Univent Replacement at Farley Elementary School
Univent Replacement at Willow Grove Elementary School
MSA File No. 42052

SED No. 50-02-01-06-0-003-011
SED No. 50-02-01-06-0-030-016

Re: ADDENDUM NO. 1

CONSTRUCTION SEQUENCE PLAN

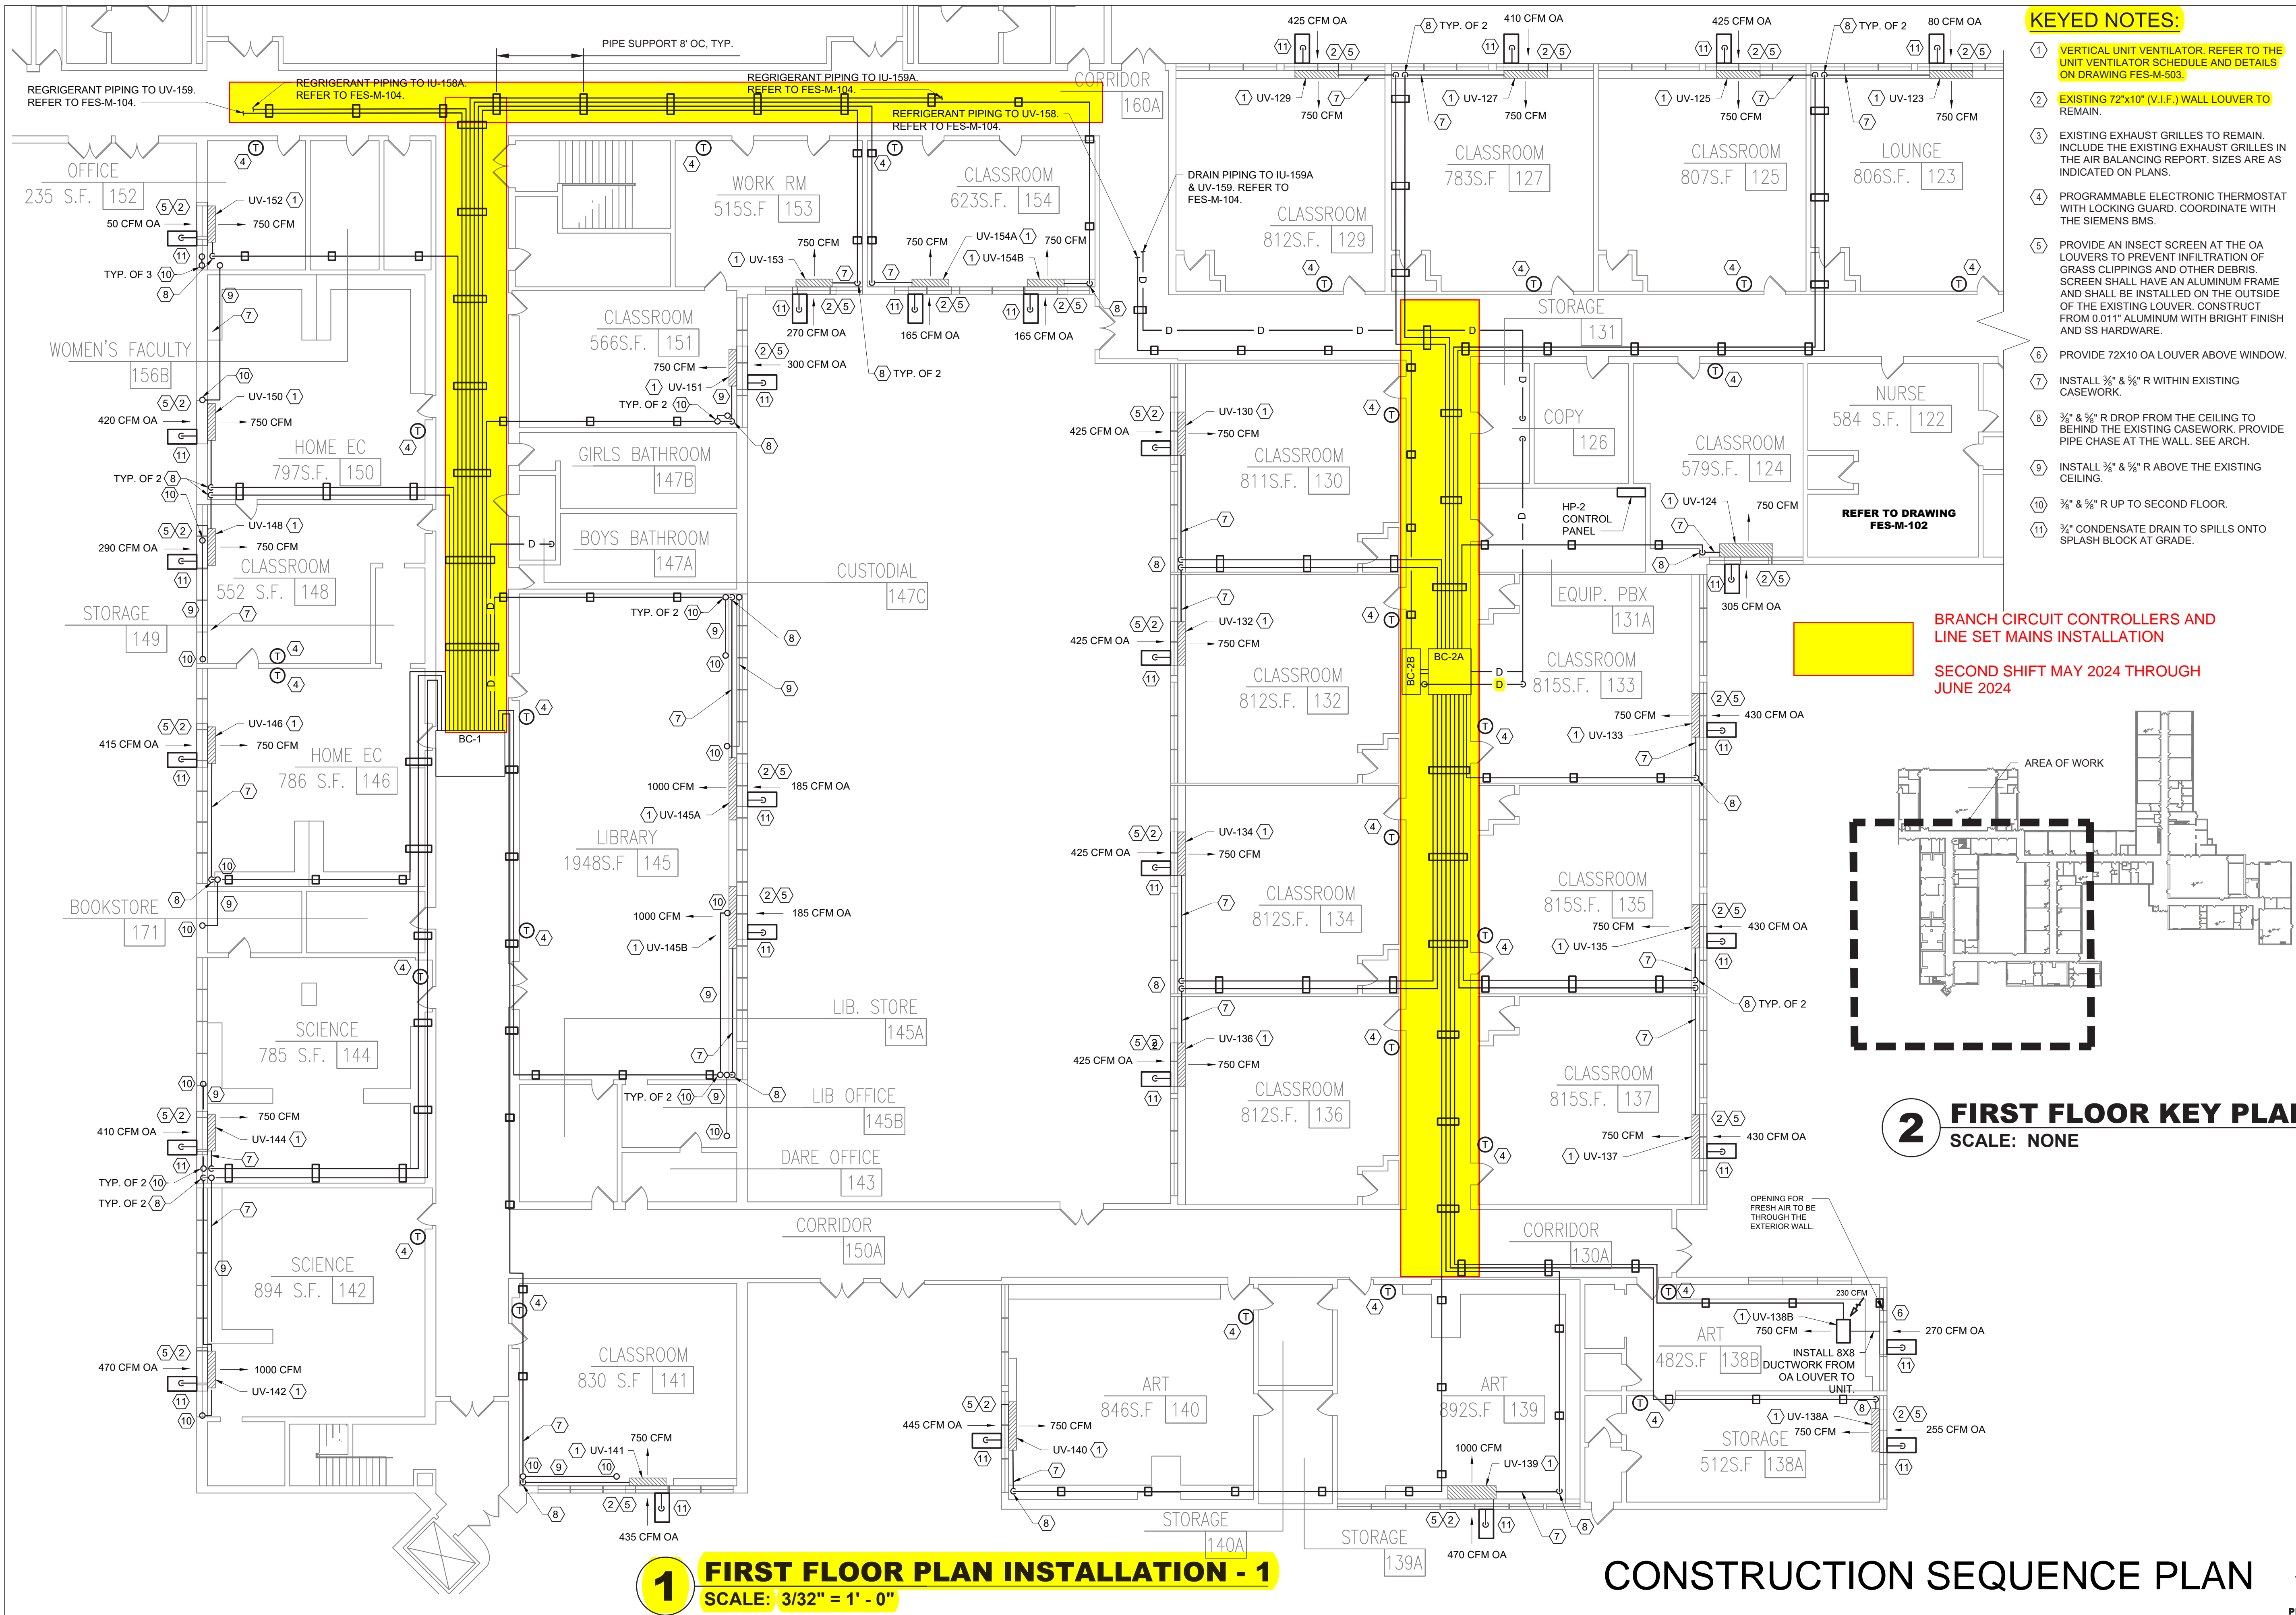
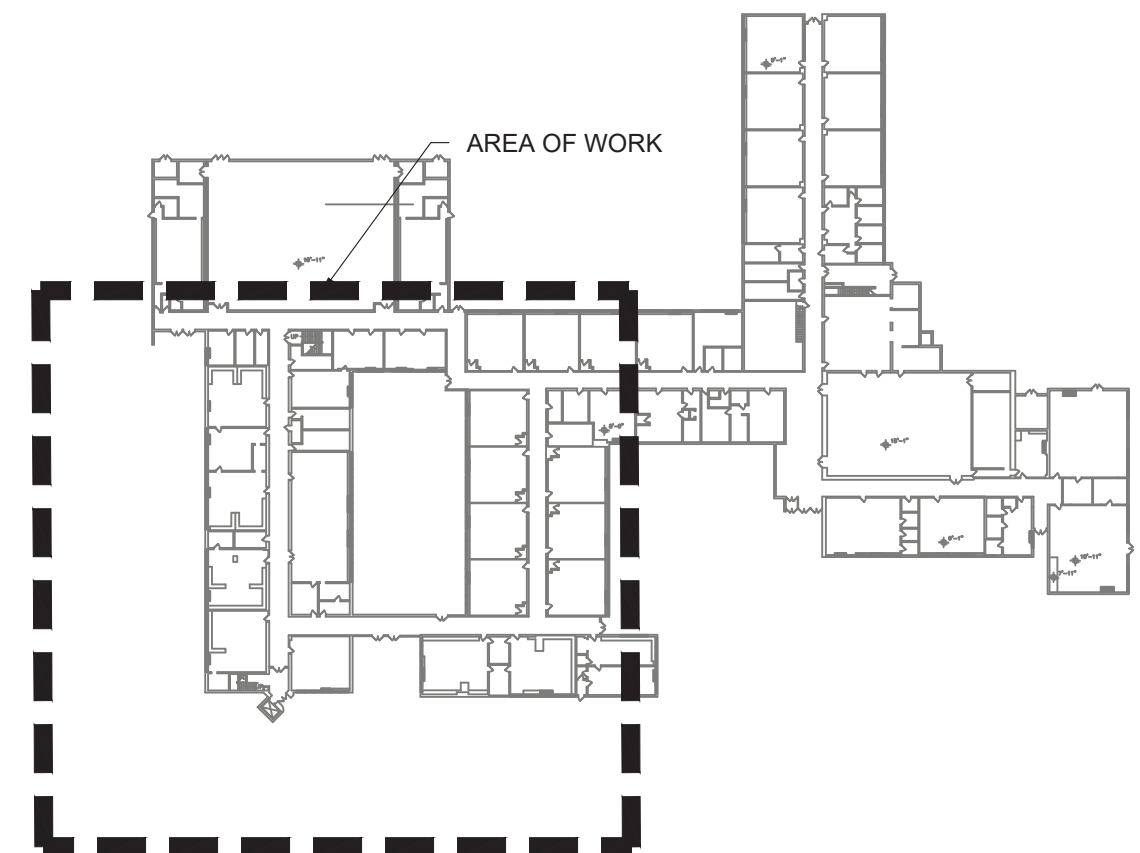
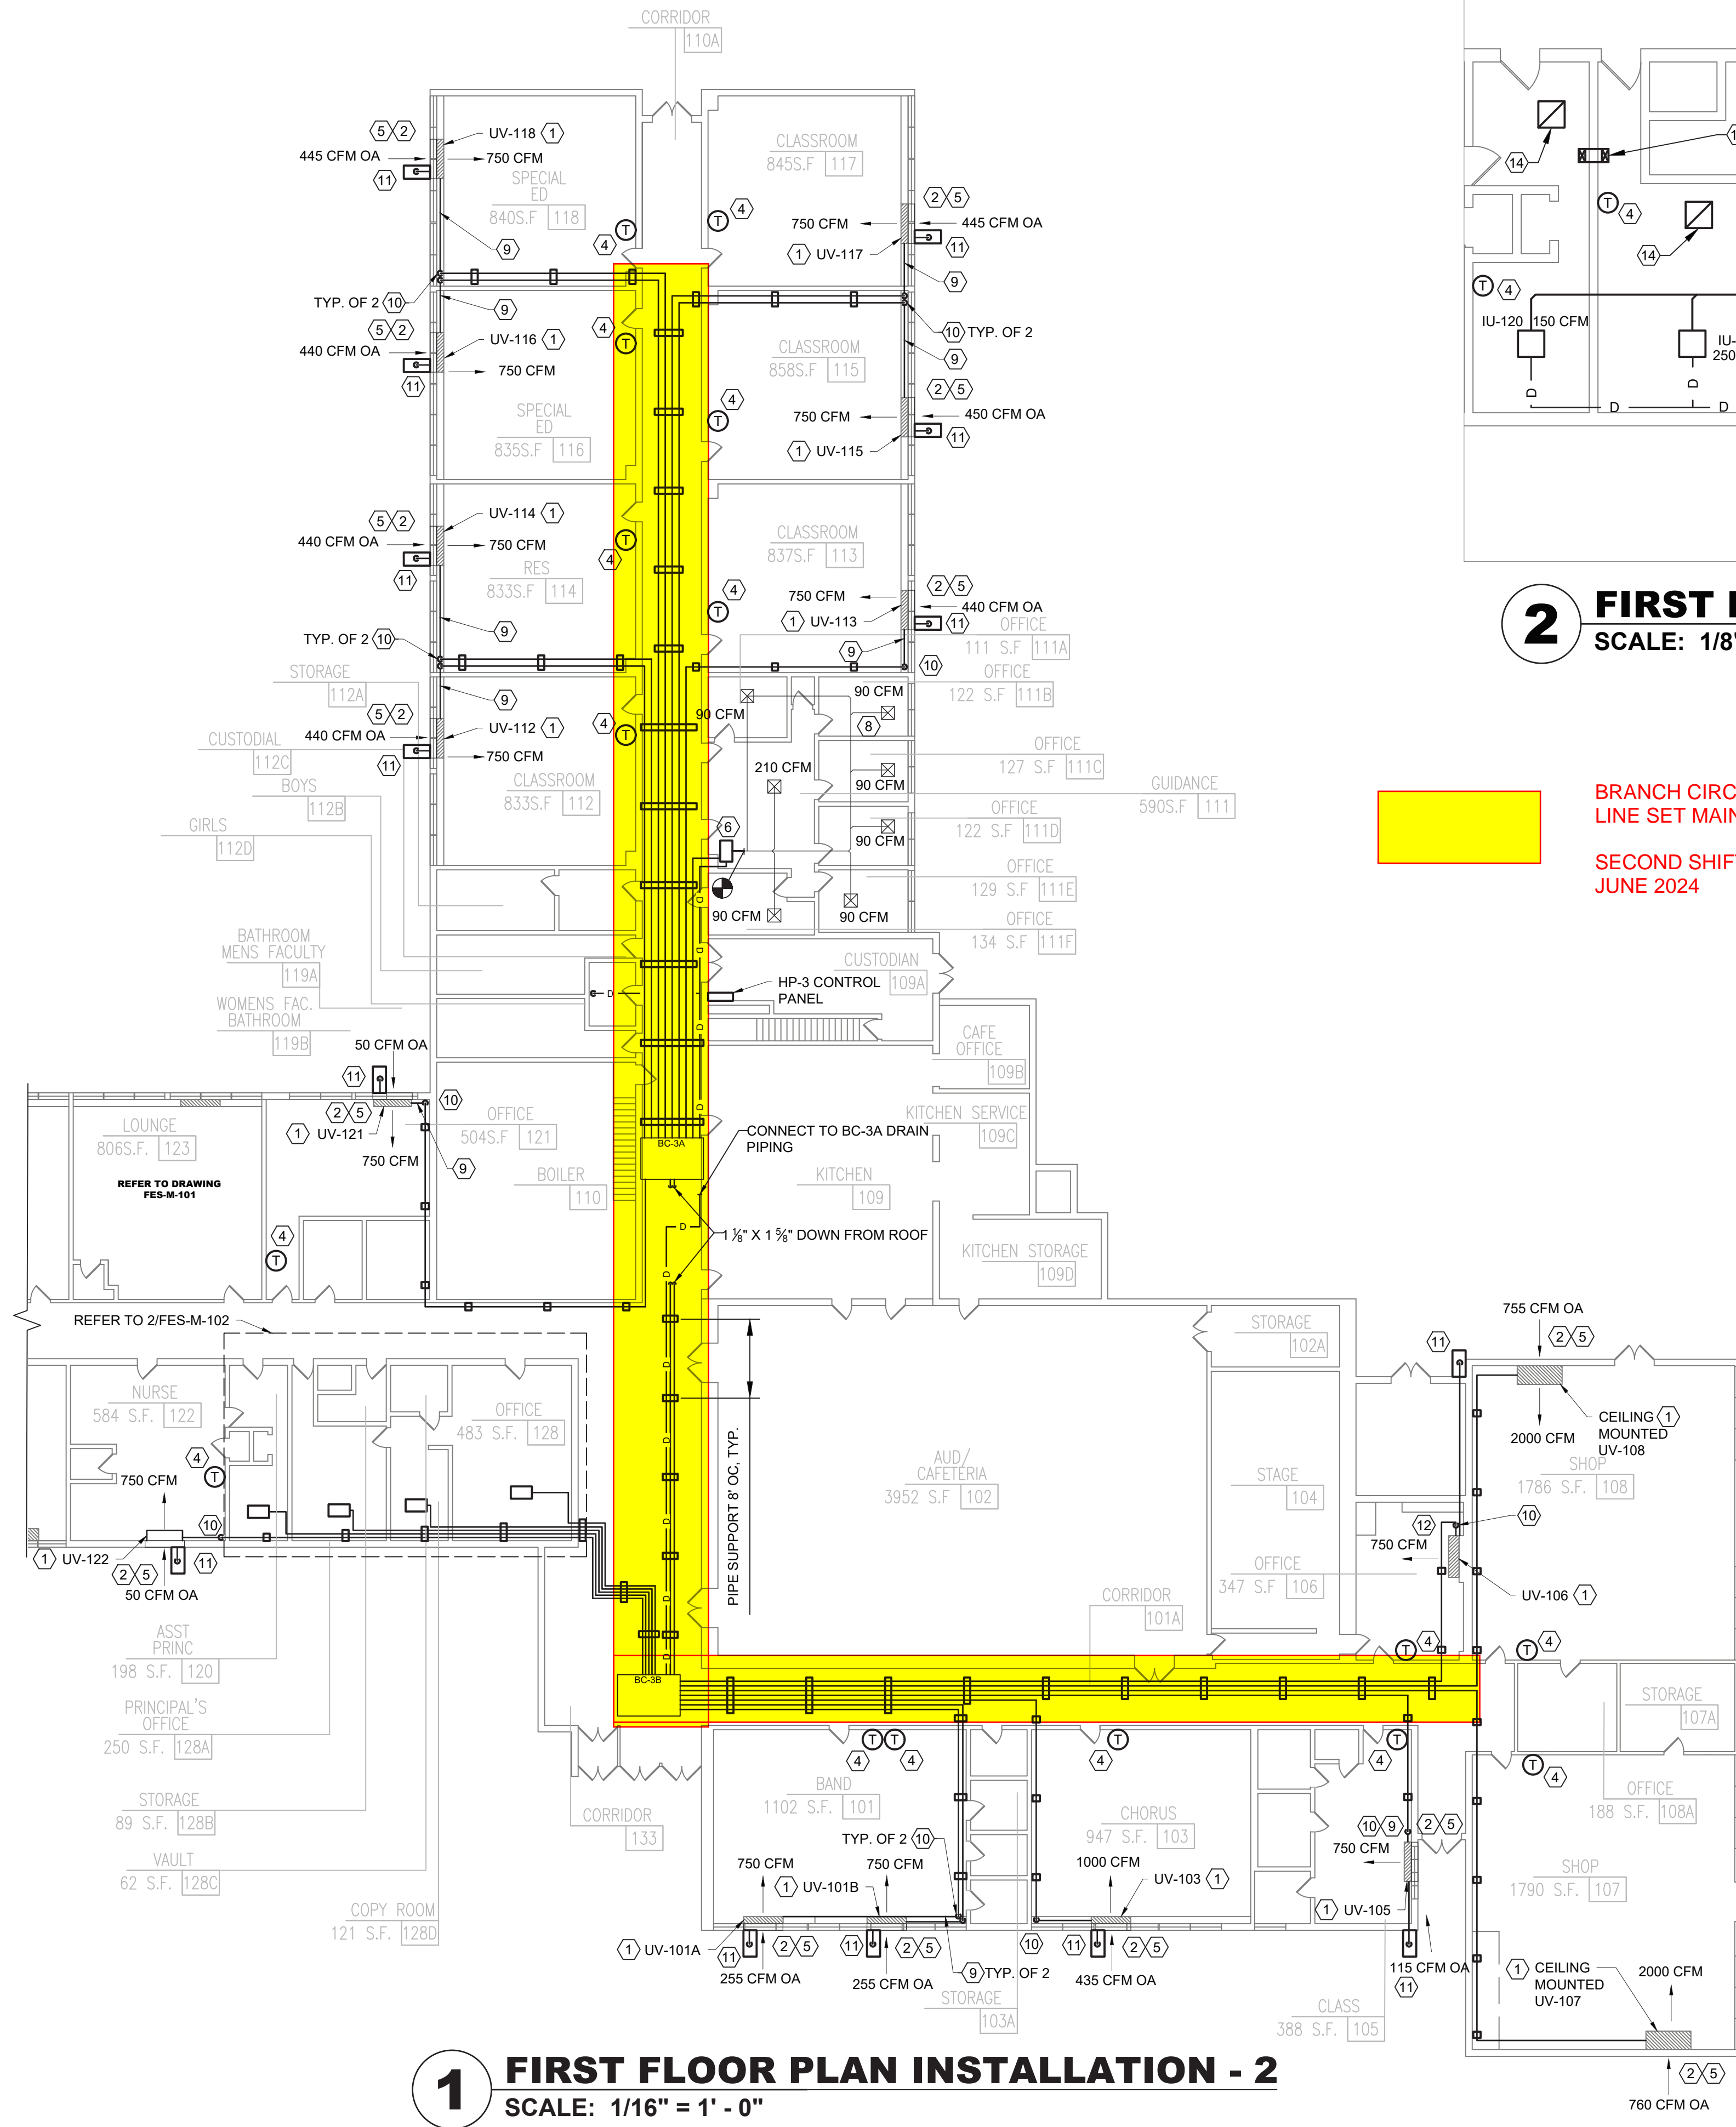
- 3) Attached are drawings regarding phasing for UV Replacement at Farley Elementary School. The drawings included are labeled with the following: CONSTRUCTION SEQUENCE PLAN.
